Technical Service Bulletin

NUMBER: 07-002-01

Elevated Engine Temperature Due To Delayed Start Of The Hydraulic Cooling Fan

2001 (WJ/WG) Grand Cherokee

FIGURE 1 - AUTHORIZED SOFTWARE UPDATE LABEL

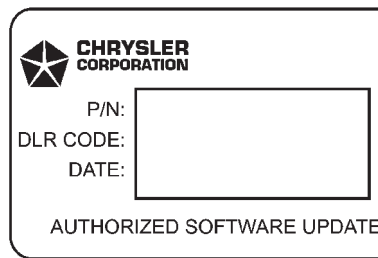
2. Type the necessary information on the "Authorized Software Update Label" p/n 04669020 (Figure 1). Attach the label to the PCM and cover the label with the clear plastic overlay.

FIGURE 2 - AUTHORIZED MODIFICATION LABEL

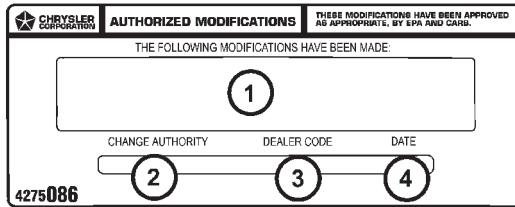
3. Type the necessary information on the "Authorized Modification Label" p/n 04275086 and attach the label near the VECI label (Figure 2).

1-	POWERTRAIN CONTROL MODULE P/N (INSERT P/N) USED
2-	CHANGE AUTHORITY: TSB XX-XX-XX
3-	DEALER CODE: XXXXX
4-	DATE: XX-XX-XX
